REQUEST FOR INFORMATION FORM
PERRIS VALLEY – BIG LEAGUE DREAMS

RFI # 57
Official use only

RFI Response

RFI # 57
Date: 04-01-10
Project: Perris Valley Big League Dreams
Project Number: 5208
Contact Person: Robert Echavarria
Title: Project Manager
Company: MIG
Phone Number: 1-714-871-3638
Subject:

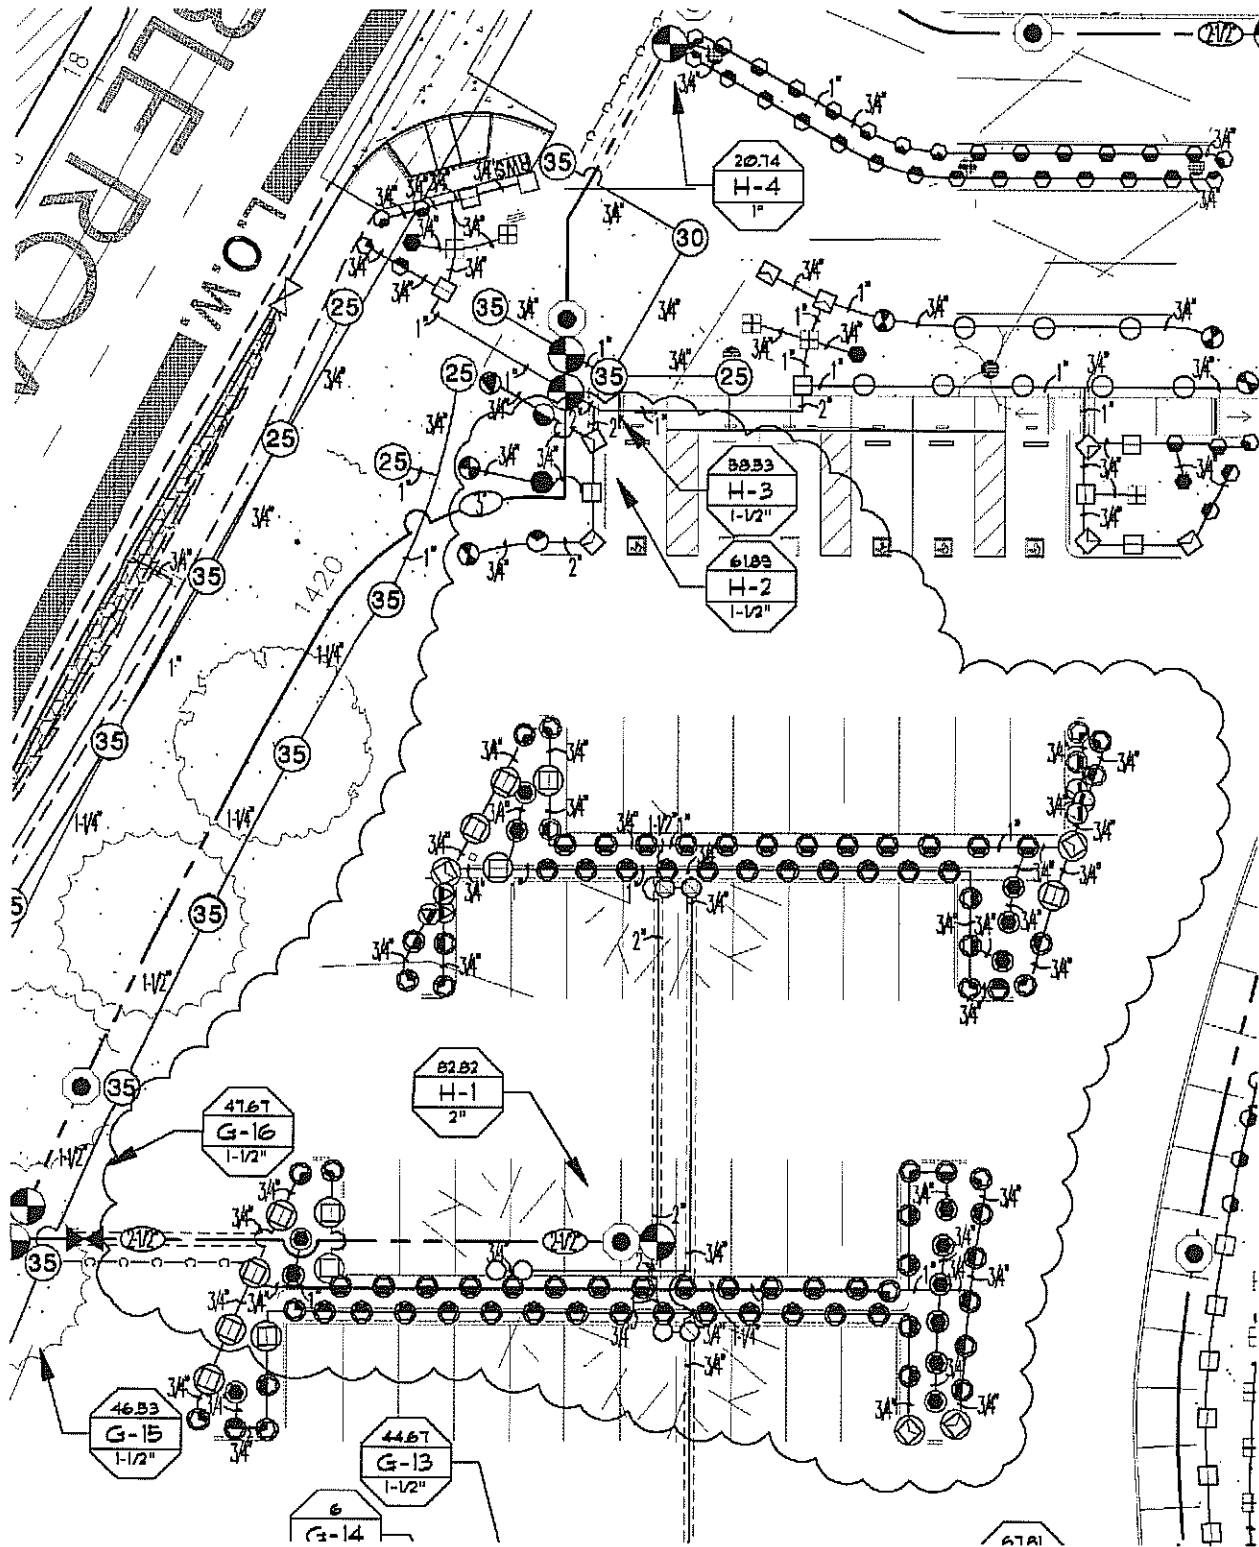
12. The pull box detail shows conduit for the wiring. Are we to assume that all the wiring for the remote control valves is in a conduit?

Pull boxes are for long wire runs of where the wire is installed in conduit and the run is greater than 250 ft. or more than 4 turns of the conduit. The control wires, when installed in planting areas, are not required to be installed in conduit. The control wires crossing hardscape are required to be installed in conduit.

SHEET #LI-1.5

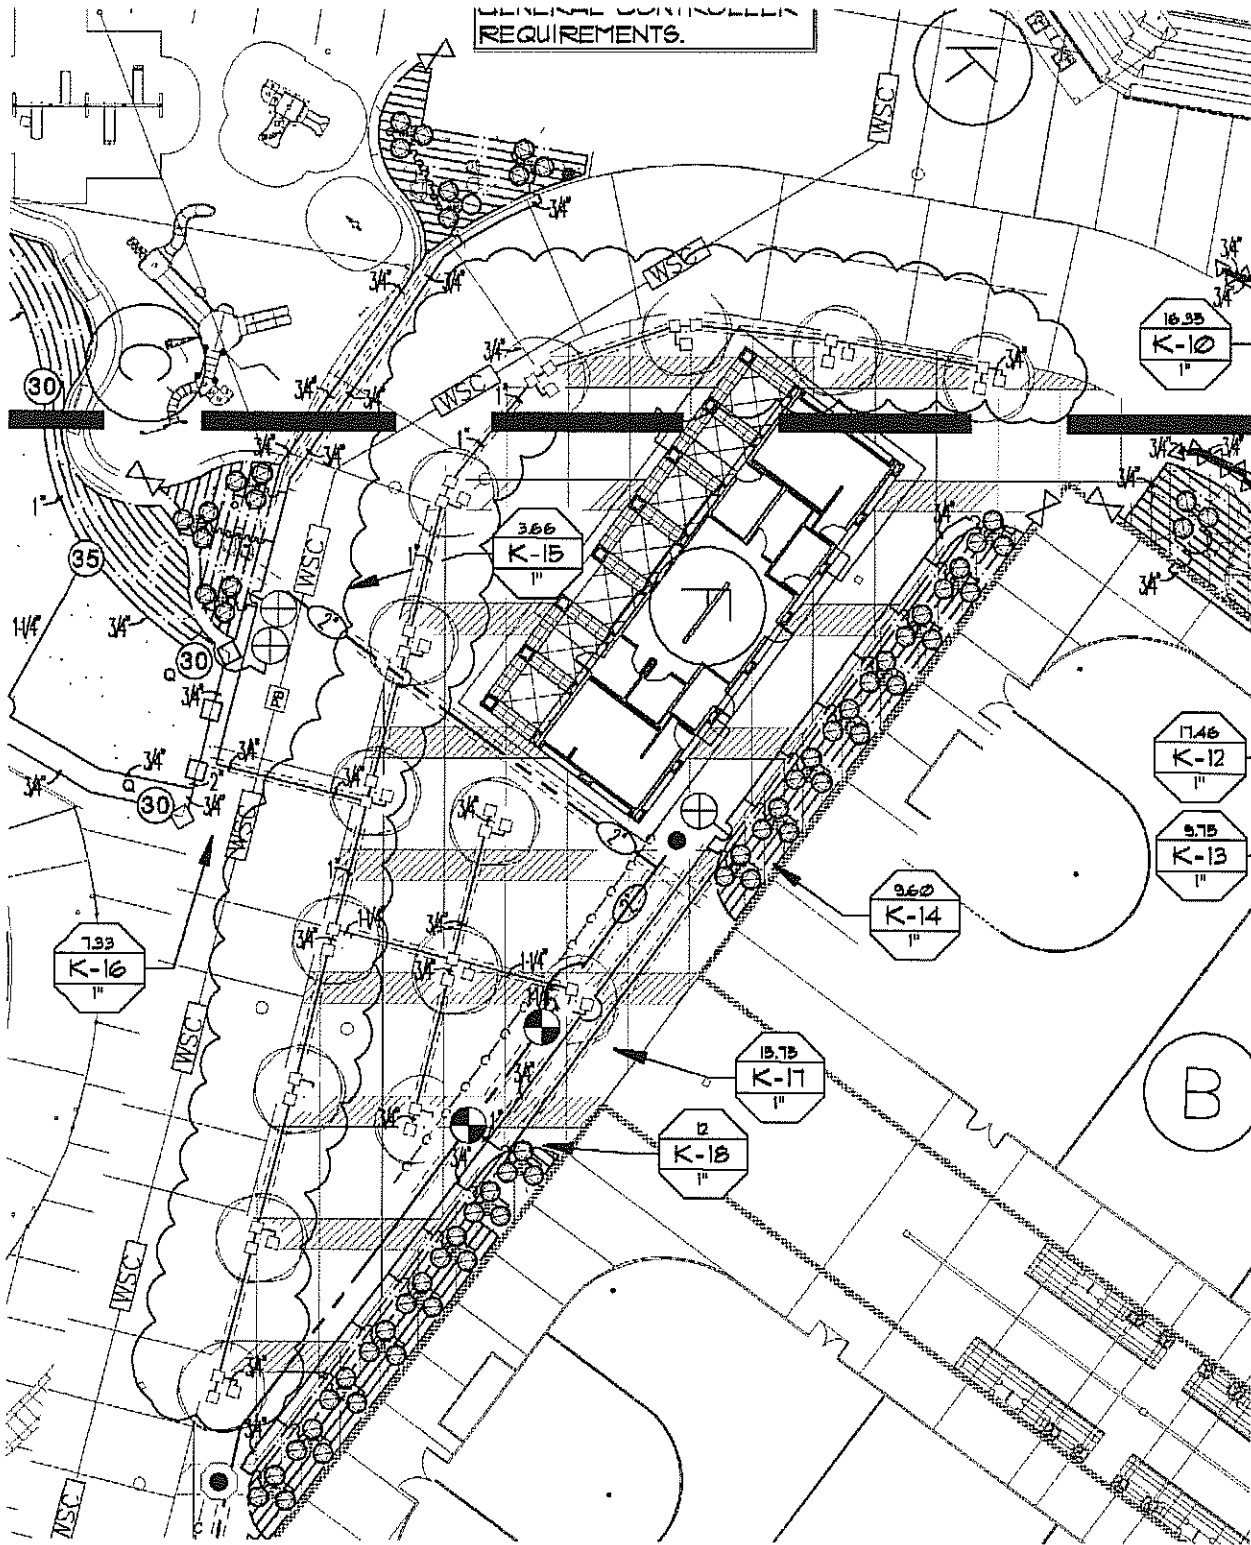
4. On sheet LI-1.5 there are two (2) planters that are being irrigated w/ turf heads. However, the same lines are connected to the same

system that will irrigate the vegetated hydro seeded areas with different moisture requirements. Please confirm that this is correct.

Please refer to attached revised irrigation plan #RFI 62.1.
